**Flood Control Project Maintenance
Levee Inspections**

Maintenance Issue Types Only, Levee Inspection Report By Mile - Fall 2018

Sacramento Maintenance Yard Putah Creek

Waterway	Bank	Unit Miles	Inspection Start/End	Inspector
Unit No. 01 Putah Creek or North Levee	Left	8.79	09/27/2018 09/27/2018	David Julian

Photo 1 of 1 : FA_2018_ST0007_282_29_20180928_00073.jpg

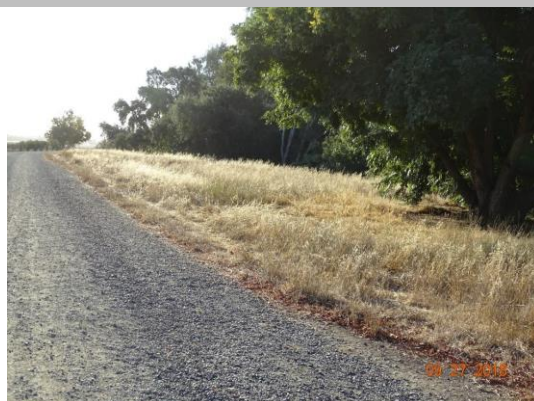
LM Start	8.34	Rating **	M	Issue No.	29
LM End	8.62	Issue Type +	Ma	Location *	WS
Category	Earthen Levee			GPS Latitude/Longitude	
				Start	End
Item	Vegetation			38.521758 °	38.523858 °
				-121.777430 °	-121.781917 °
DWR ID	DWR_ST0007_01_f_2018_29				
Comment Code					
V1 : Control annual grass and weeds on the levee slopes and easements.					
Inspector Comment					
Maintain vegetation on water side slope.

View looking downstream at thick vegetation up to the crown (September 2018).

Photo 1 of 1 : FA_2018_ST0007_283_47_20180924_00013.jpg

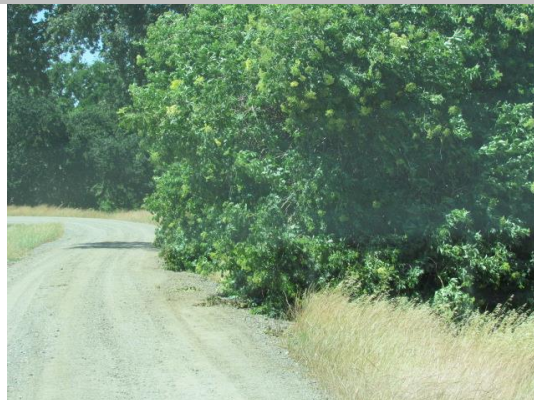
LM Start	7.00	Rating **	U	Issue No.	47
LM End	7.01	Issue Type +	Ma	Location *	WS
Category	Earthen Levee			GPS Latitude/Longitude	
				Start	End
Item	Vegetation			38.522328 °	38.522393 °
				-121.781447 °	-121.781663 °
DWR ID	DWR_ST0007_02_s_2017_47				
Comment Code					
V4 : Elderberries are blocking visibility and flood fight capability.					
Inspector Comment					
These Elderberries are blocking view of levee section and blocking access to a portion of the shoulder waterward. Some of these stalks are less than 1.0 inch that could be thinned out.

Elderberry bushes blocking view of waterside shoulder at this location.
